# UNITED STATES PATENT AND TRADEMARK OFFICE

APPLICATION NO.	FILING DATE	FIRST NAMED INVENTOR	ATTORNEY DOCKET NO.	CONFIRMATION NO.
10/507,119	09/10/2004	George Kammler	016906-0322	4162

<b>Office Action Summary</b>	<b>Application No.</b> 10/507,119	<b>Applicant(s)</b> KAMMLER, GEORGE	
	<b>Examiner</b> JOSEPH CORRIGAN	<b>Art Unit</b> 3744

## **DETAILED ACTION**

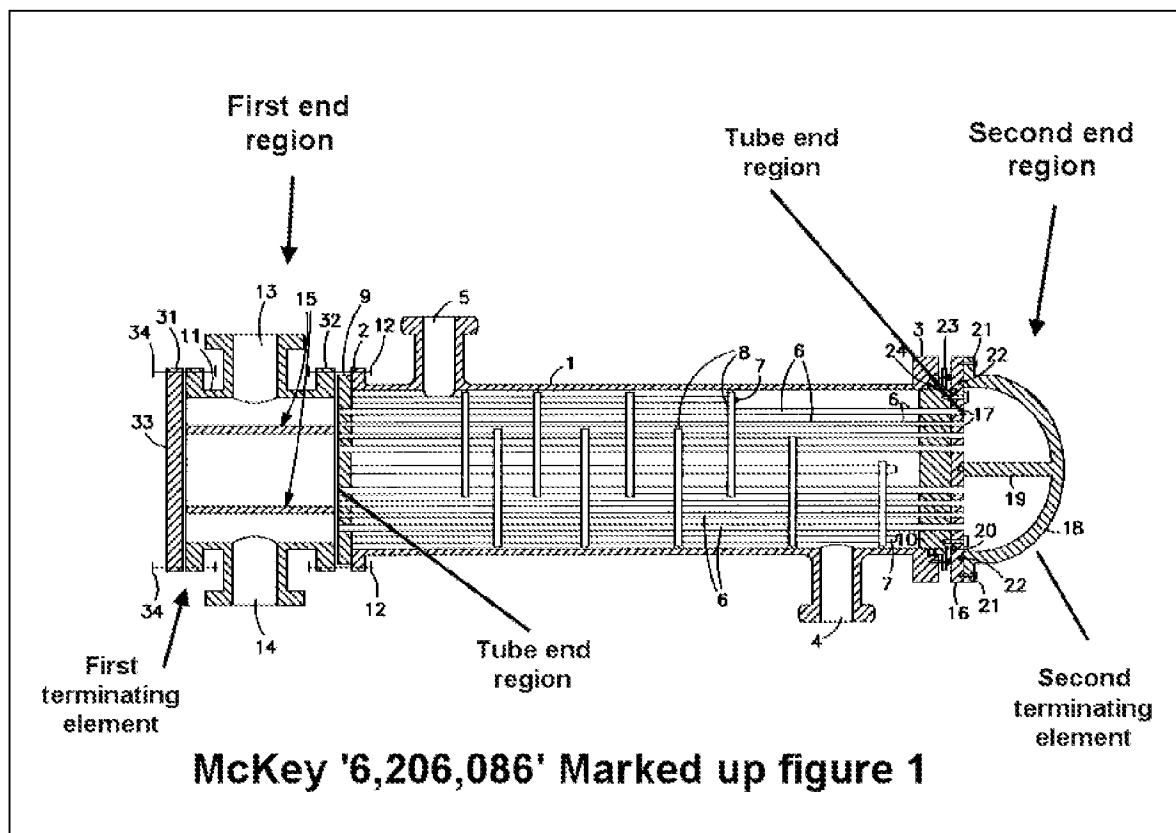
In re claim 23, McKey '086 discloses a heat exchanger (see figure 1) comprising: first (33, figure 1) and second (18, figure 1) terminating elements; at least one tube (6, figure 1) through which a first medium is configured to flow, wherein the at least one tube (6, figure 1) comprises a first end region connected to the first terminating element (see marked up figure 1) and a second end region (see marked up figure 1) connected to the second terminating element (see marked up figure 1); a first tube part (see

In re claim 40, McKey '086 discloses the invention above and further discloses that the plurality of tubes (6, figure 1) are each connected, at their respective first end regions (see marked up figure 1), to the first terminating element (see marked up figure 1) and are each connected, at their respective second end regions, to the second terminating element. (See marked up figure 1).

In re claim 41, McKey '086 discloses the invention above and further discloses that at least one of the first and second end regions (first end region, marked up figure 1) of the at least one tube (6, figure 1) is connected to a connection element (13, figure 1) for supplying the first medium, discharging the first medium, or a combination thereof.

In re claim 42, McKey '086 discloses the invention above and further discloses that at least one of the first and second terminating elements (first terminating element, marked up figure 1) is connected to at least one connection element (13, figure 1) for supplying the first medium, discharging the first medium, or a combination thereof.

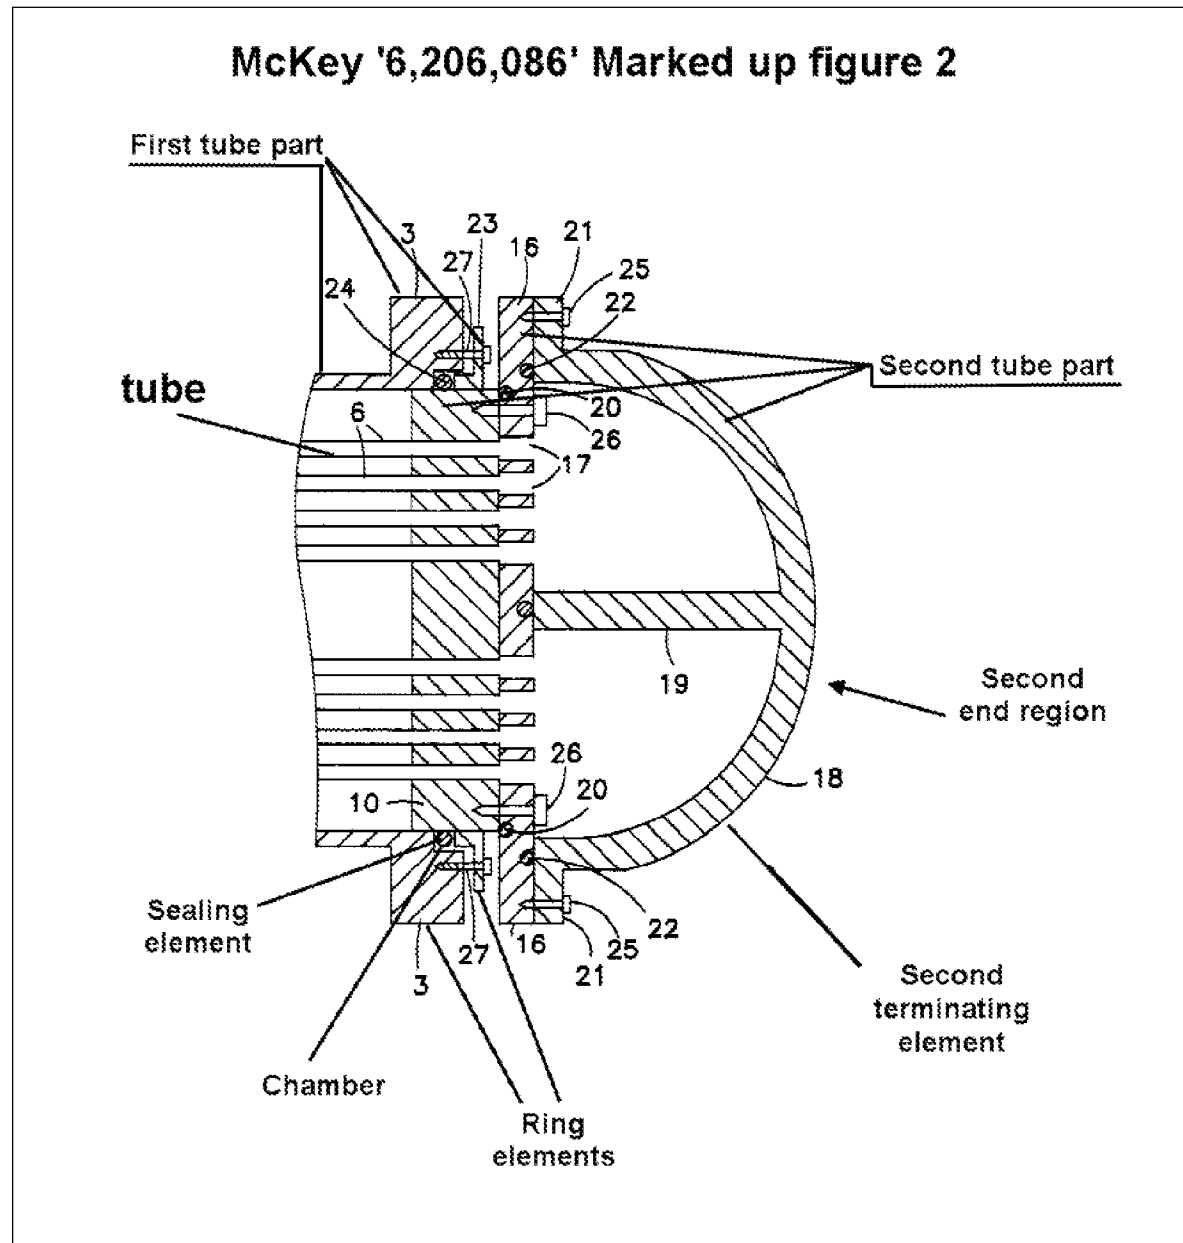
marked up figure 2) connected to the first terminating element (see marked up figure 2); a second tube part (see marked up figure 2) connected to the second terminating element (marked up figure 2), wherein the first and second tube parts (see marked up figure 2) run radially into one another at least over a partial region of their axial extent , wherein one of the first and second tube parts (first tube part, see marked up figure 2) comprises two continuous ring-like elements (see marked up figure 2) protruding radially towards the other of the first and second tube parts (second tube part, see marked up figure 2); and at least one sealing element (24, figure 2, C3, L42-45) disposed between the two ring-like elements in a spatial region between the first and

In re claim 24, McKey '086 discloses the invention above and further discloses that at least one chamber (see marked up figure 2) is formed between the first tube part (see marked up figure 2) and the second tube part (see marked up figure 2) by the two

In re claim 25, McKey '086 discloses the invention above and further discloses that the at least one chamber (see marked up figure 2) is formed by the first tube part (see marked up figure 2) and a second tube part (see marked up figure 2).

In re claim 26, McKey '086 discloses the invention above and further discloses that the chamber is at least substantially sealed off by the two ring-like elements. (See marked up fig. 2).

In re claim 28, McKey '086 discloses the invention above and further discloses that the chamber is at least partially filled with an elastic medium (24, figure 2, packing, C3, L41-45) which comprises the at least one sealing element (see marked up figure 2).

In re claim 34, McKey '086 discloses the invention above and further discloses that the continuous ring- like elements is spaced apart in an axial direction (see marked up figure 2).

In re claim 35, McKey '086 discloses the invention above and further discloses that the continuous ring- like elements form integral constituents of the first tube part (see marked up figure 2).

In re claim 36, McKey '086 discloses the invention above and further discloses that the continuous ring- like elements are additional components connected to the one of the first and second tube parts. (See marked up figure 2 which illustrates that “continuous rings” are considered “additional” components since components are distinctive features to basic design).

In re claim 39, McKey '086 discloses the invention above and further discloses that the at least one tube comprises a plurality of tubes (6, figure 2) through which the first medium flows, wherein the plurality of tubes are arranged substantially parallel to one another radially inside the first and second tube parts. (See marked up figure 2).

**Lucke '2,512,748' Marked up figure 4**

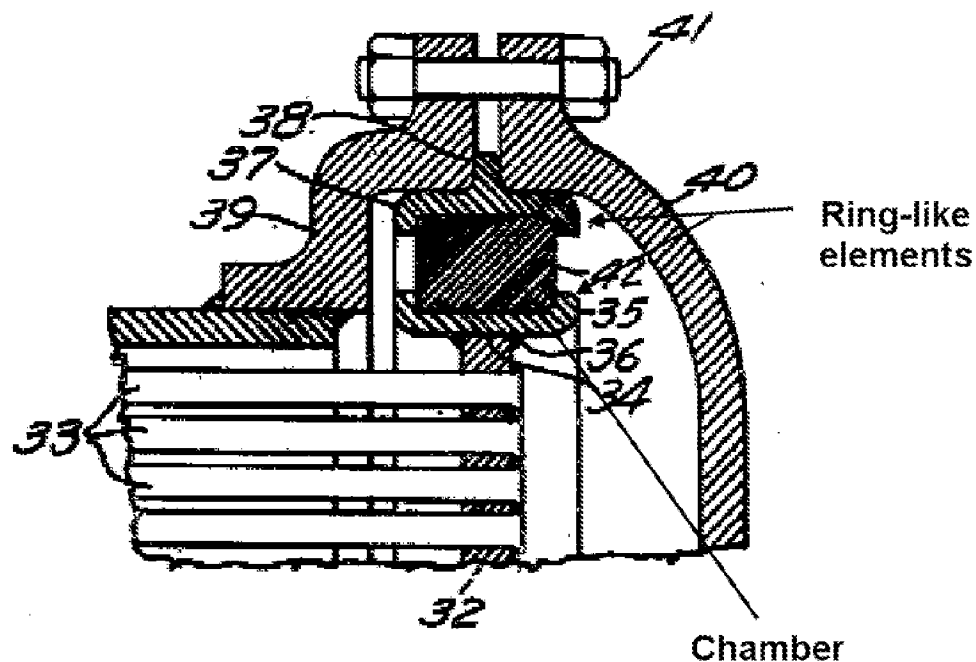
Lucke '748 discloses a chamber not sealed off by the two ring-like elements (See marked up figure 4).

Lucke '748 discloses that the chamber is filled such that the elastic medium forms an annular element (42, C3, L27-30) extending radially between the first and second tube parts. (See marked up figure 4).

Lucke '748 discloses that the at least one sealing element is laid into the chamber as a ring element. (See marked up figure 4, element 42, C3, L27-30 regarding annular rubber body).
